PLACER COUNTY WATER AGENCY

Re: Comments on Bay Delta Conservation Plan, Implementing Agreement and Draft EIR/EIS

SUBJECT: Technical Comments on Bay-Delta Conservation Plan Modeling

Figure 1. Inflow to Trinity, Shasta, Oroville, and Folsom Reservoirs – NAA, NAA-ELT and NAA-LLT

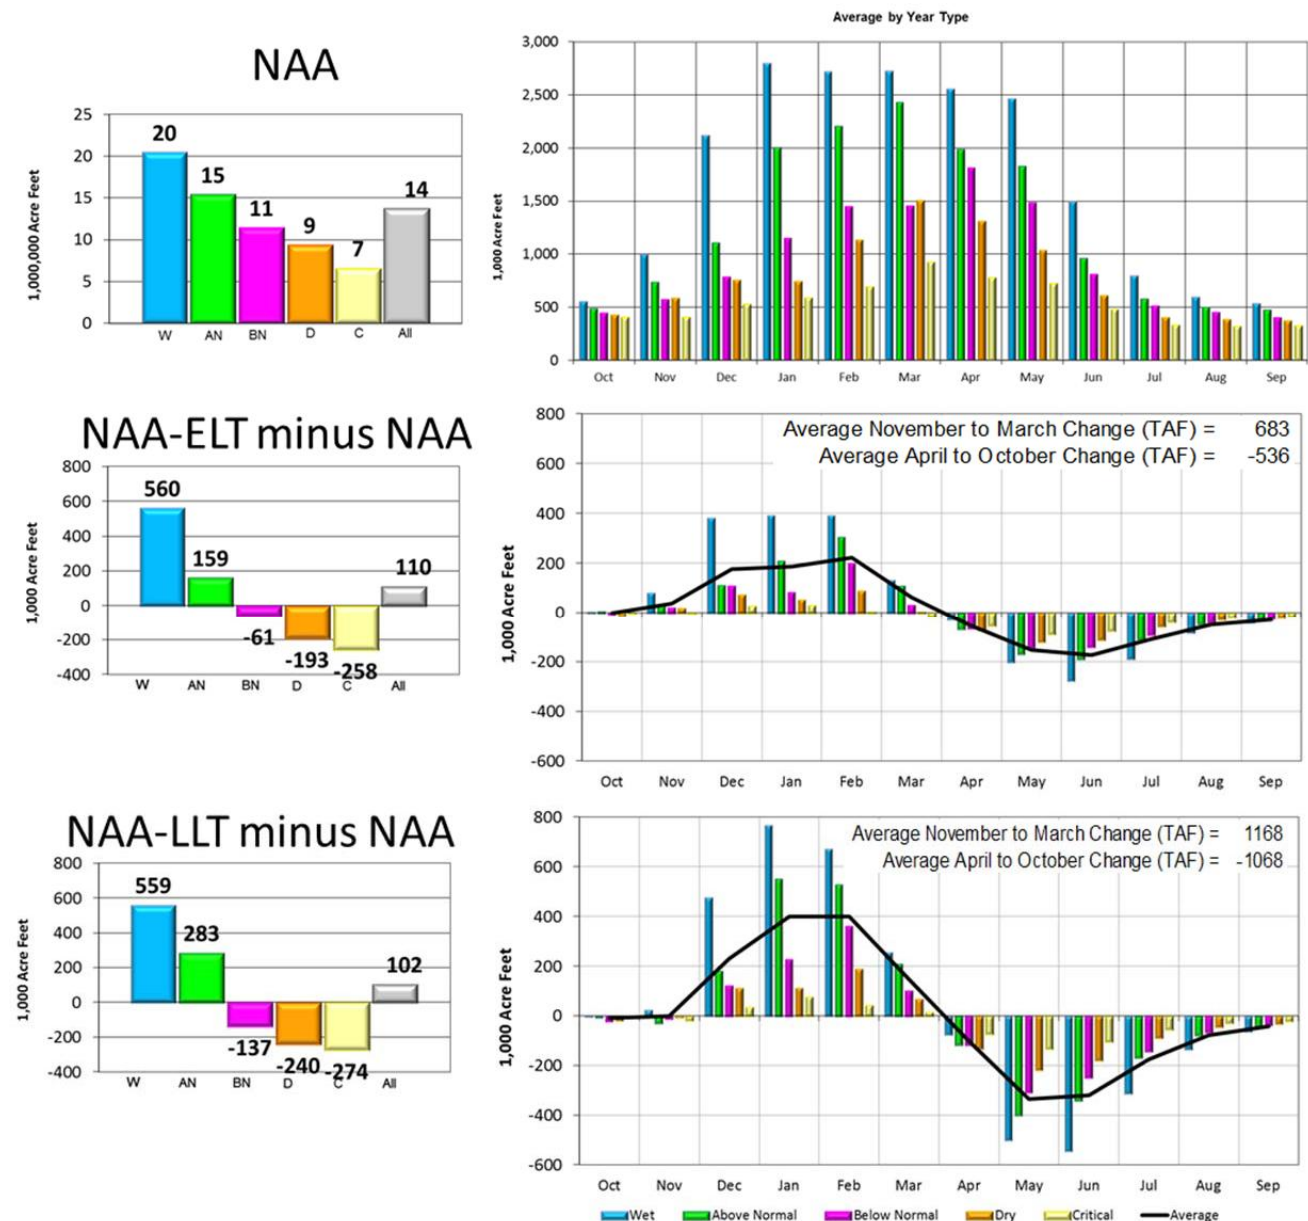
Comparison of inflow changes illustrated in Figure 1 and Figure 2 show the effects of climate change are large in the American River Basin relative to changes in other river basins. Total changes illustrated in

Figure 1 show wetter conditions in wet years and drier conditions in dry years when considering the four basins together. However, climate change in the American River Basin for the LLT shows drier conditions in all year-types. Additionally, a large percentage of the dry and critical year inflow reduction, 57 and 37 percent respectively, for the combined four basins occur in the American River Basin. By comparison, runoff from the American River at Folsom is approximately 20 percent of the sum of runoff of the Trinity, Sacramento, Feather, and American rivers.

Figure 2. Projected Inflow to Folsom Reservoir – NAA, NAA-ELT and NAA-LLT

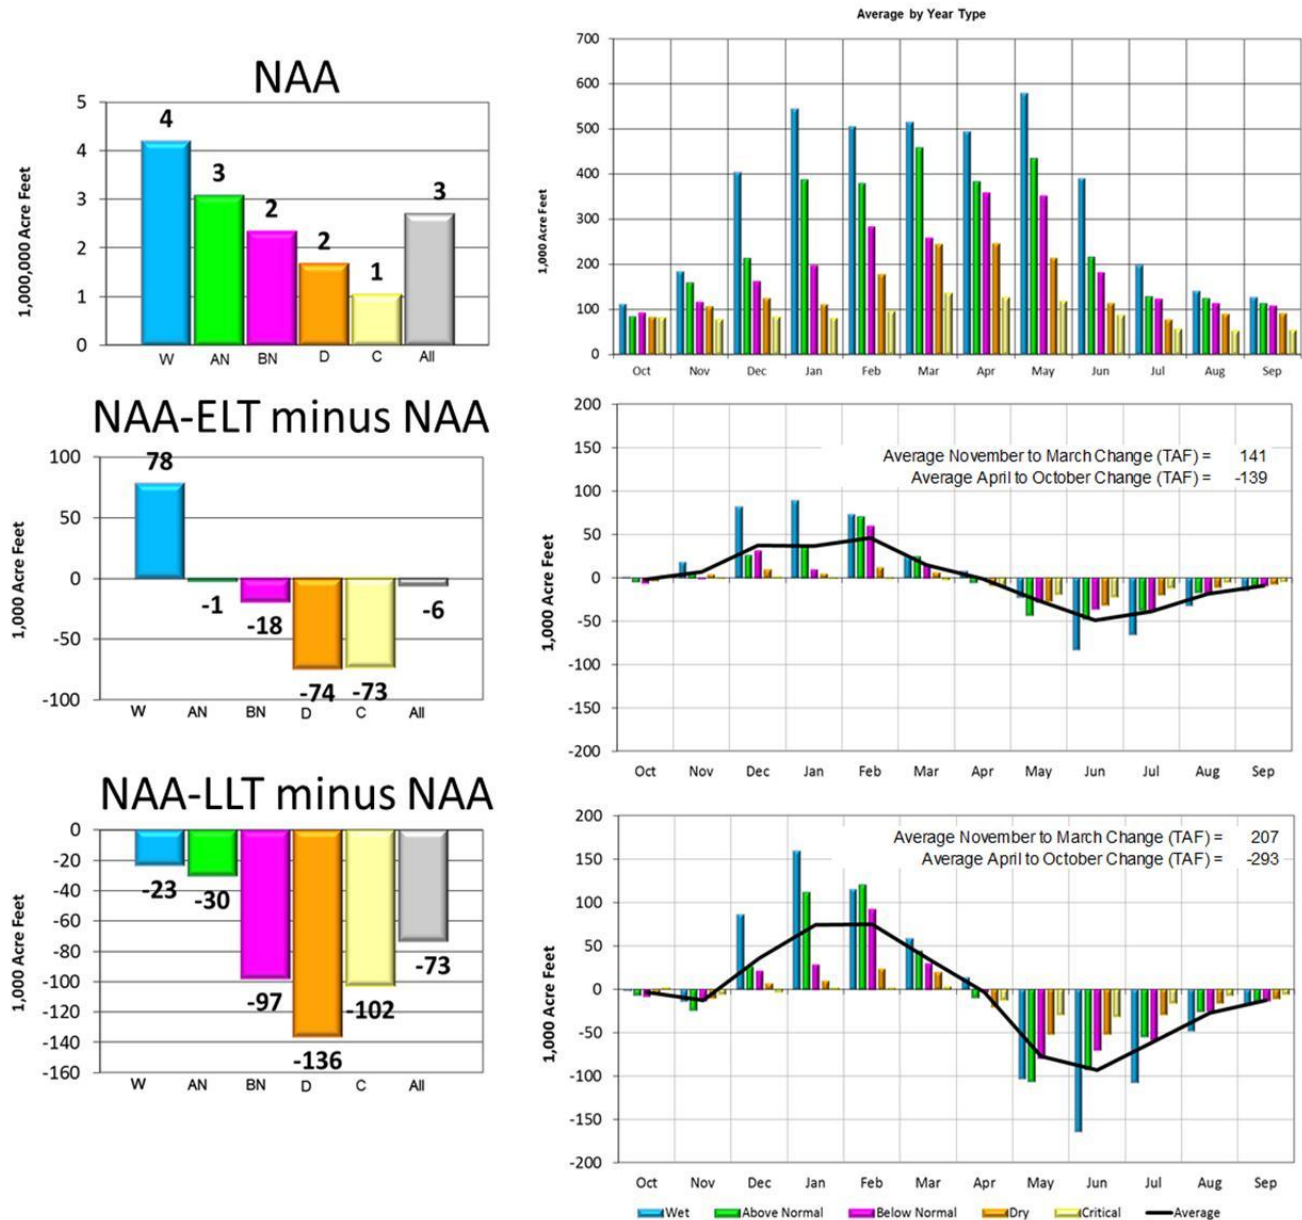
The effect of assumed climate change on average annual Folsom Reservoir inflow in the NAA-ELT scenario is minor, but causes decreases in inflow of about 70 TAF in the NAA-LLT scenario. The spring to winter shift in runoff is also projected for Folsom Reservoir inflow. Figure 2 is an illustration of Folsom inflow under the NAA and the change relative to NAA for the NAA-ELT and NAA-LLT baselines. To properly incorporate climate change into modeling of Folsom Reservoir and the American River, climate change effects must be applied to flows and reservoirs upstream from Folsom, which was not done. There is significant storage capacity in the upper American River watershed in PCWA's Middle Fork Project and the Sacramento Municipal Utility District's (SMUD) Upper American River Project. The

operation of Folsom is significantly affected by changes in upstream conditions and operations.⁹ Because climate change in BDCP modeling is imposed on the American River by adjusting only the inflow to Folsom only, however, the effect on the American River is likely misrepresented in the BDCP NAA-ELT and NAA-LLT scenarios.

Figure 3. Folsom Reservoir Carryover Storage

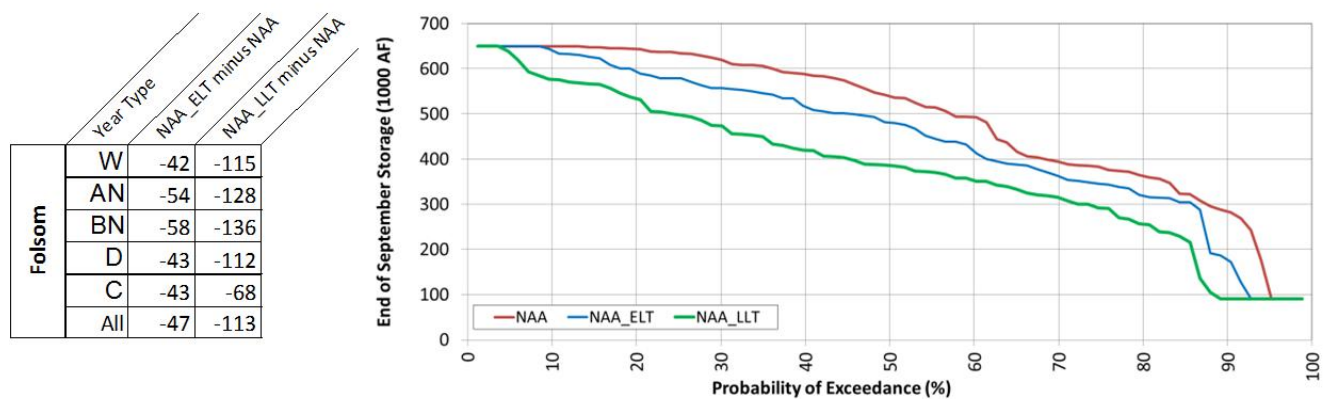
For Folsom and other upstream CVP and SWP reservoirs, the shift of in timing of inflows along with a continuing need to satisfy downstream environmental requirements and demands significantly affects carryover storage. Because of climate change’s assumed effect on hydrology and the lack of CVP/SWP operational adaptations in the BDCP modeling, the CVP and SWP simply cannot satisfy water demands and regulatory criteria imposed on them in the NAA-ELT and NAA-LLT modeling scenarios. Figure 3 illustrates change in carryover storage in Folsom Reservoir. The relatively high frequency (approximately 10% of time) of minimum storage occurring at Folsom Reservoir leads us to question whether the NAAs reflect credible or defensible operations. The projected occurrences of low and dead storage conditions projected by the BDCP modeling result in severe reduction of flow available to sustain habitat in the Lower American River and severe reductions in water supply reliability.

Figure 4. CVP North of Delta M&I Water Service Contract Allocation

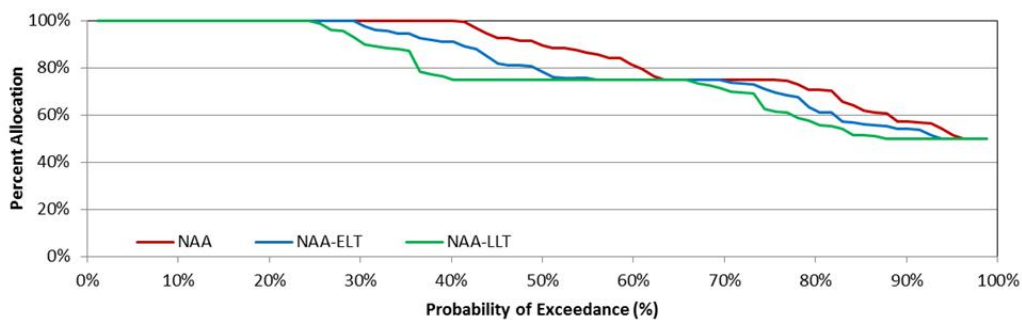
Assumed effects of climate change and lack of adaptation reduces CVP water supply allocations to American River CVP Water Service Contractors. Figure 4 contains exceedance probability plots of CVP M&I allocations for the NAA, NAA-ELT, and NAA-LLT scenarios. Full allocations are made 40% of the time under the NAA, this is reduced to about 30% in the NAA-ELT, and full allocations are made about 25% of the time in the NAA-LLT. The occurrence of 50% allocation increases from about 4% in the NAA to about 7% in the NAA-ELT and to about 12% in the NAA-LLT. In addition to reduced water service contract allocations, water supply allocations under any right cannot be satisfied due to low storage levels in Folsom Reservoir and low flow in the Lower American River. It is not physically possible to divert water for M&I use from Folsom Reservoir when reservoir storage drops below about 100,000 acre-feet because, at that level, the M&I intake in the reservoir would be dry. In addition, flows in the lower American River below about 500 cfs make it impossible for the City of Sacramento to divert water at its Fairbairn diversion. The water-supply and other effects of these physical conditions occurring in the NAA scenarios are not identified or evaluated in the draft BDCP EIR/EIS.

Figure 5. NAA-LLT and Alt 4-LLT Simulated Folsom Reservoir Elevation

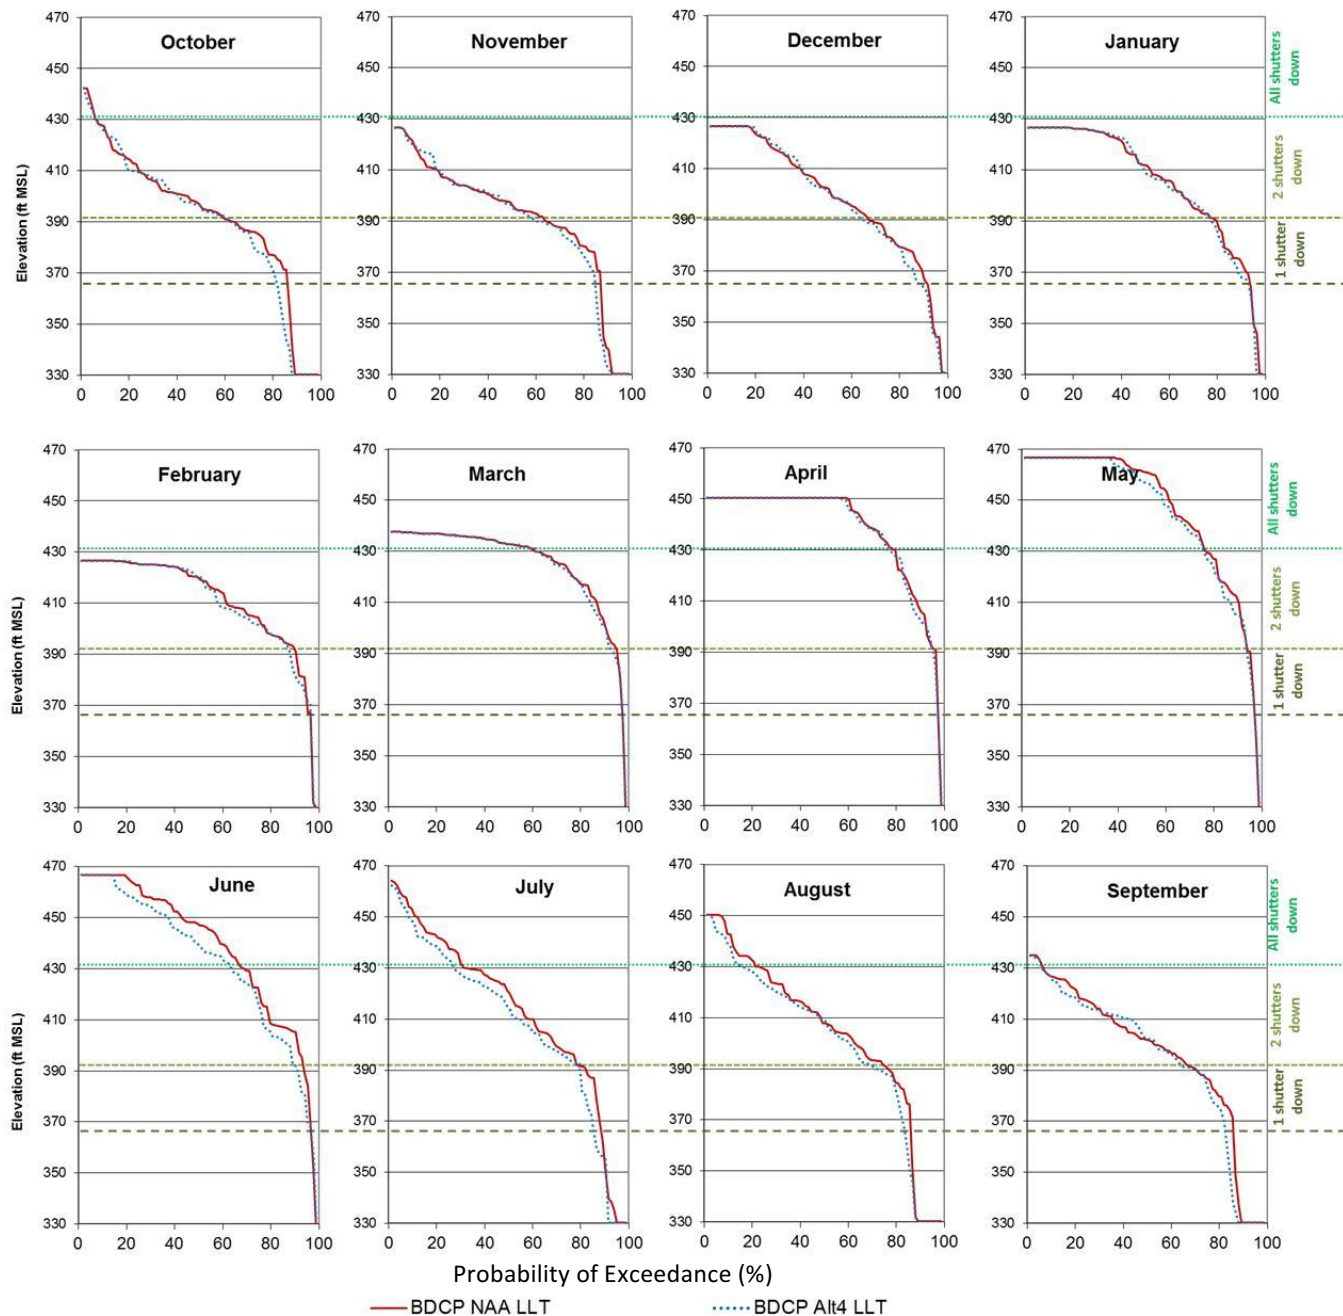
Figure 5 is a comparison of simulated monthly Folsom Reservoir water surface elevations for the baseline and with-Project scenarios. A probability of exceedance chart for each month illustrates differences between the two model simulations and potential Project effects. Dashed horizontal lines indicate water surface elevations when groups of shutters on the intake device must be removed. For example, when the water surface elevation goes below approximately 430 feet, the first group of shutters must be removed. These lines are 30 feet above the top of shutter elevations for the three groups of shutters to account for water depth to prevent the formation of a vortex and cavitation at the intake which would prevent diversion.

Results presented in Figure 5 illustrate that Folsom Reservoir water surface elevation is lower under the with-Project scenario. The largest difference in Folsom elevation occurs from June through August and can affect temperature management by changing when shutters are removed. Shutters are removed from Folsom Dam's intakes in order to access colder water located lower in the reservoir. While removing shutters causes the temperature of water diverted and released from the reservoir to drop almost immediately, that effect does not cause release temperatures to remain cooler indefinitely. Accordingly shutters must be removed strategically.

The timing of shutter removal at Folsom Reservoir would change in the with-project condition. For example, in August the probability of all three shutters being in use is reduced from approximately 25 percent to 15 percent, and the probability of at least one shutter still in used is reduced from approximately 90 percent to 85 percent. Figure 6 is a comparison of simulated monthly Folsom

Figure 6. NAA-LLT and Alt 4-LLT Simulated Folsom Reservoir Storage

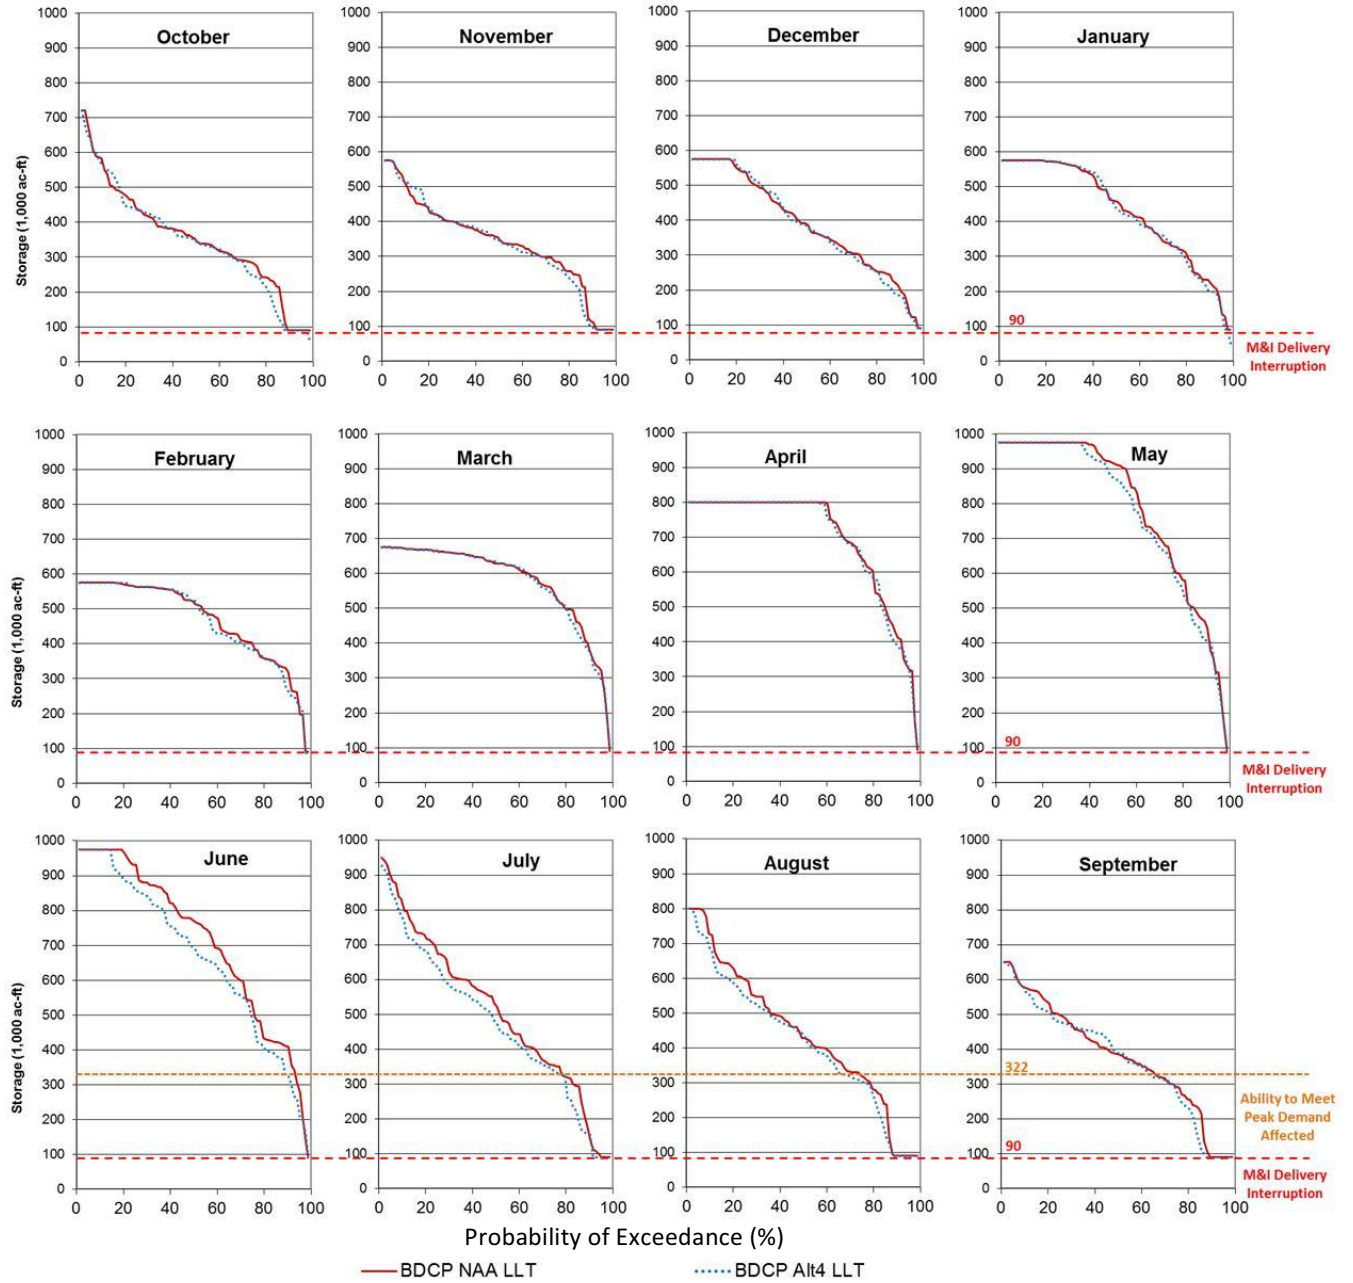
Reservoir storage for the baseline and with-Project scenarios. A probability of exceedance chart for each month illustrates differences between the two model simulations and potential Project effects. Dashed horizontal lines in Figure 6 represent storage levels below which M&I water purveyors cannot meet peak demands (322 TAF) with diversions from Folsom (illustrated for peak demand months only) or when M&I diversions are interrupted because water levels in Folsom are below the M&I intake (90 TAF). Results summarized in Figure 6 show that Folsom Reservoir storage is more likely to be lower under the BDCP Alt4-LLT than the NAA-LLT particularly in peak summer months. Lower storage impacts the ability of the water purveyors that divert directly from Folsom Reservoir, as well as downstream purveyors on the American River, to meet peak demands in the summer and increases the probability of M&I delivery interruptions.
